REPUBLIC AVIATION CORPORATION
FARMINGDALE, LONG ISLAND, NEW YORK
SERVICE DEPARTMENT

OPTIONAL CHANGE

SERVICE BULLETIN NO. 17

INSTALLATION STEERABLE TAIL WHEEL

Figure 9

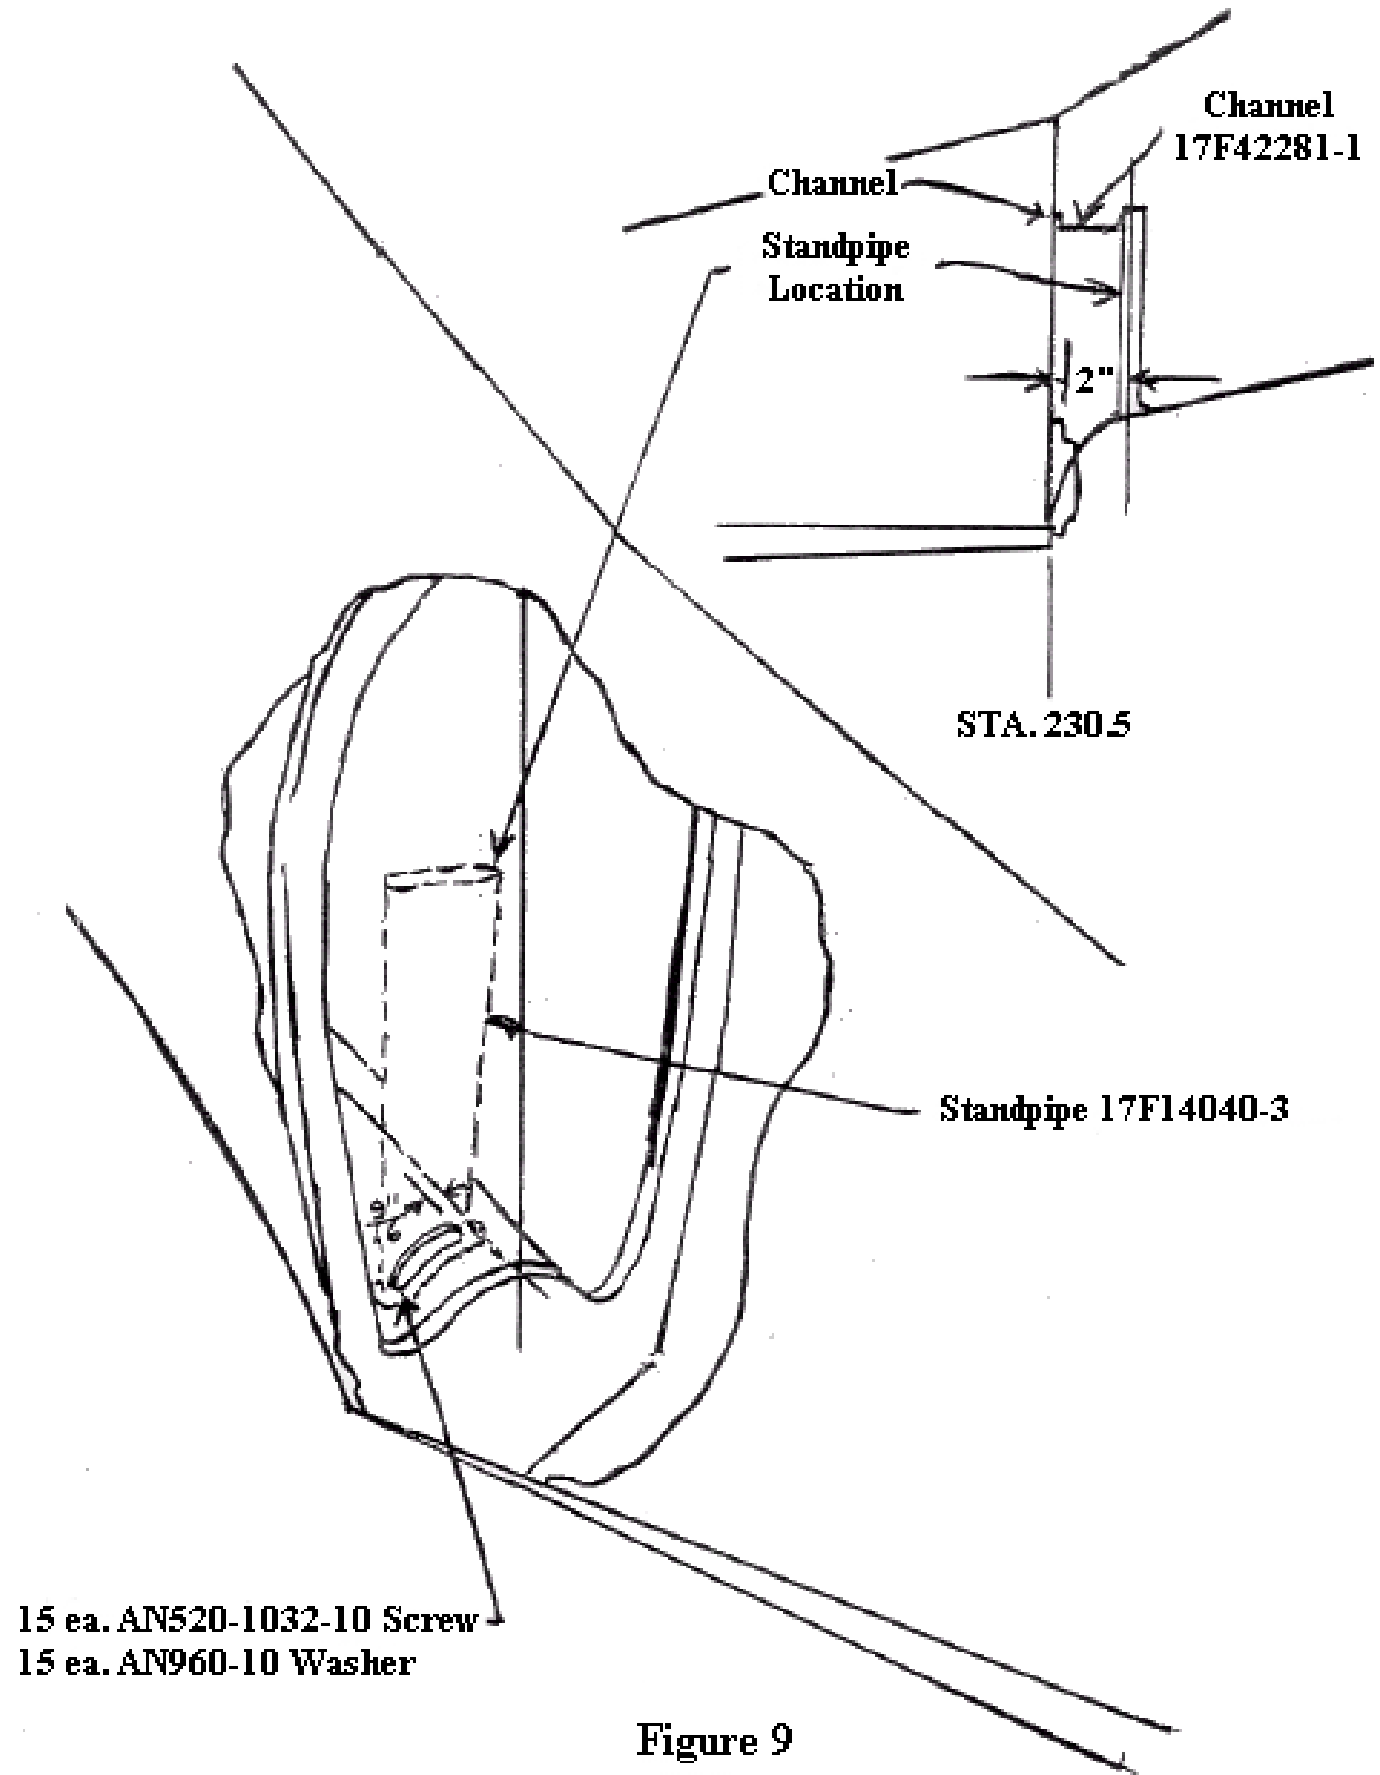
1. Install Standpipe 17F14040-3 and Plate 17F14040-5 as follows referring to Figure 9:
 - a. Place Plate 17F14040-5 against flange of Standpipe 17F14040-3 and check alignment of plate nuts on flange of standpipe with pilot holes in plate. Open up pilot holes in plate with a #10 (.194) drill being sure to compensate for any misalignment.
 - b. Draw a line on the hull 2 inches aft of the aft surface of the tail wheel shock absorber bearing.
 - c. Place plate so that inboard edge of hole in it is 9/16 inches to the right of the vertical centerline of the airplane. The long centerline of the elongated hole in the plate should be on the line drawn under (b) above. Scribe hole to be cut in hull using hole in plate as guide. Cut hole in hull.
 - d. Using holes in plate as guide, drill fifteen (15) #10 (.194) holes through hull.

Figure 11

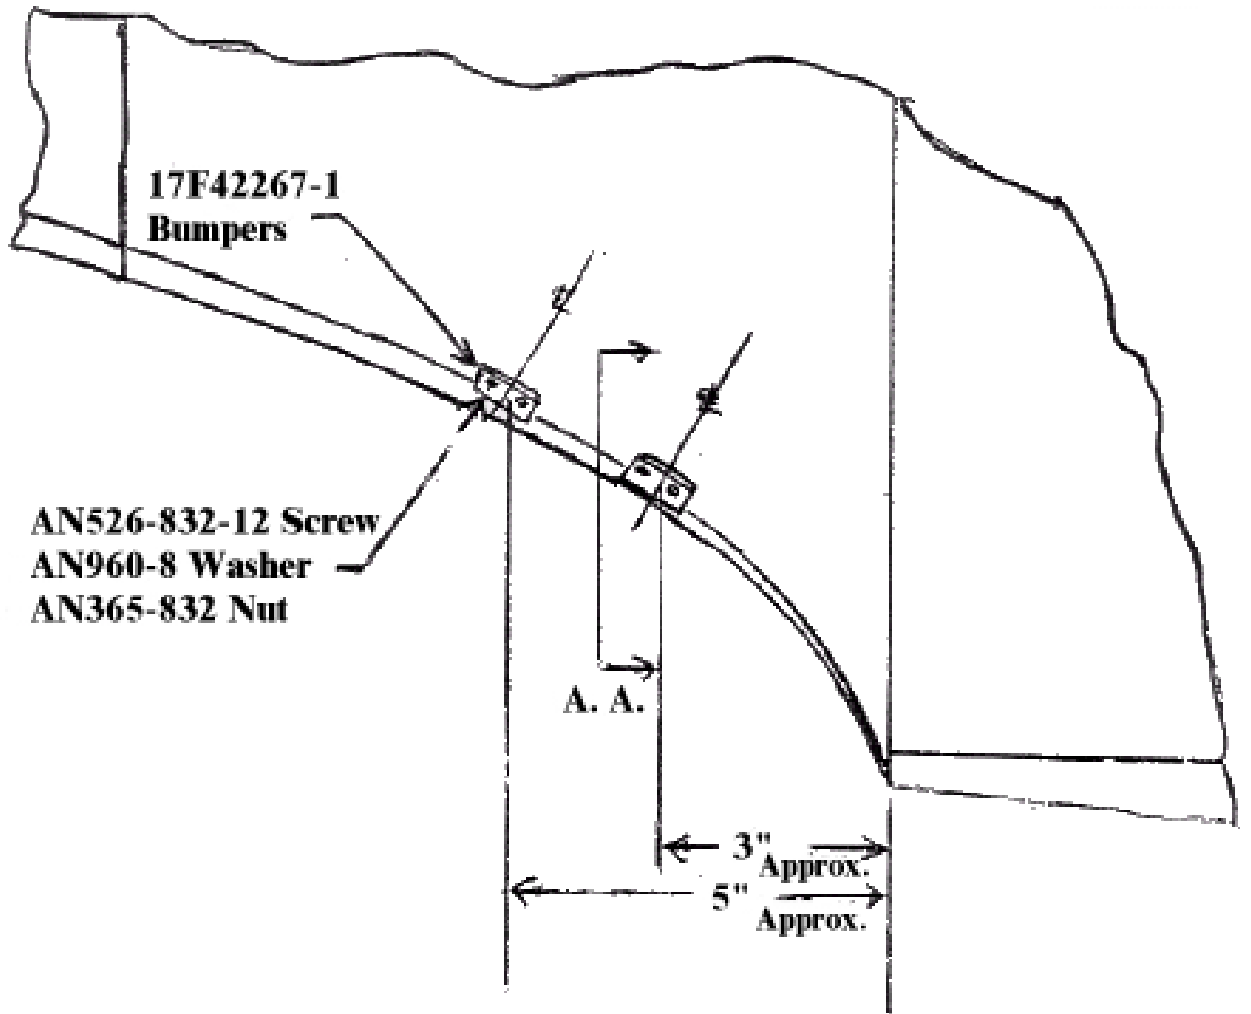
- e. Install Channel 17F42281-1 in place as shown picking up two existing bolts through bulkhead Station 230.5.
- f. Install two Bumpers 17F42267-1 as follows referring to Figure 11:
 - (1) Position of bumpers on right side of tail boom is to be determined by tail wheel fork in retracted and full swivel position. Mark location of interference with fork on tail boom.
 - (2) Place bumpers at points of interference and using holes in bumpers as guides drill four #19 (.166) holes for each bumper.

NOTE: If bumper overlaps skin splice, locate bumpers so that no holes are drilled in skin splice. If necessary use only two attaching holes.

Figure 1

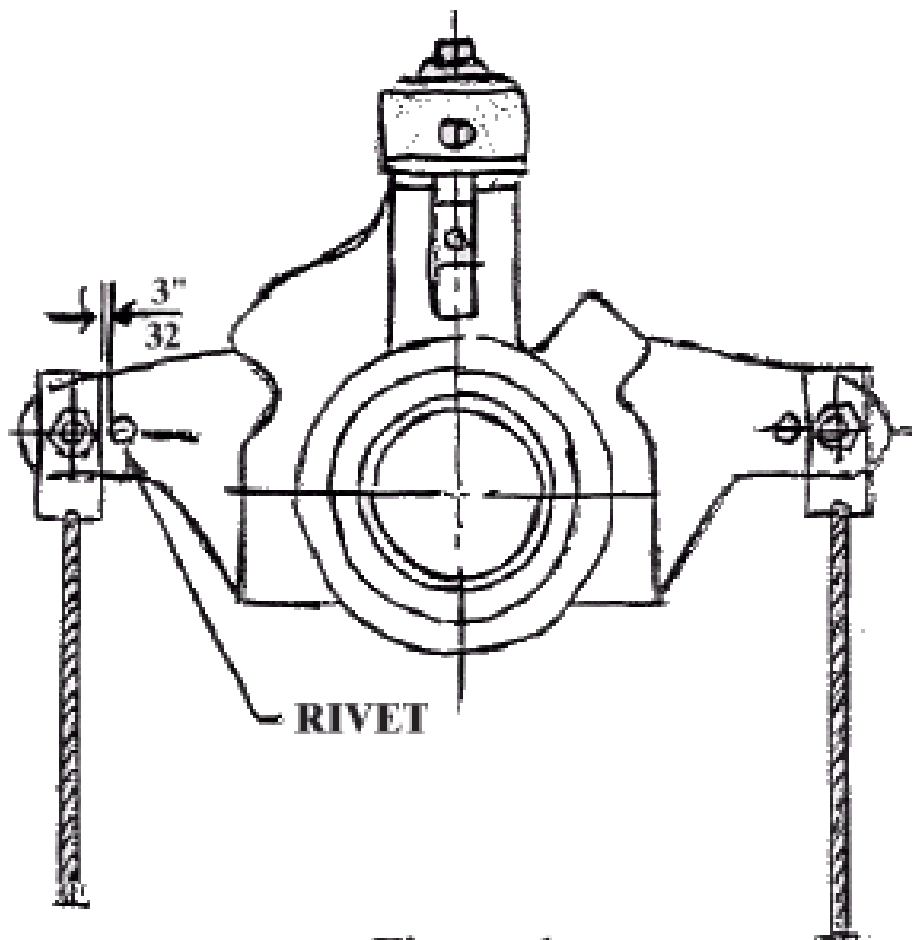
To prevent steerable tail wheel control cable terminals from swiveling one hundred and eighty degrees on the quadrant when the tail wheel is retracted, rivets are placed along side the terminals. If the cable terminals swivel there is danger of breaking the cables. Some of the early quadrants shipped in kits did not have these rivets installed. Please inspect these quadrants and if the rivets are not evident, install a rivet, screw or bolt so that there is $\frac{3}{32}$ -inch clearance between the inboard edge of the terminal and edge of the head of the rivet, screw or bolt.
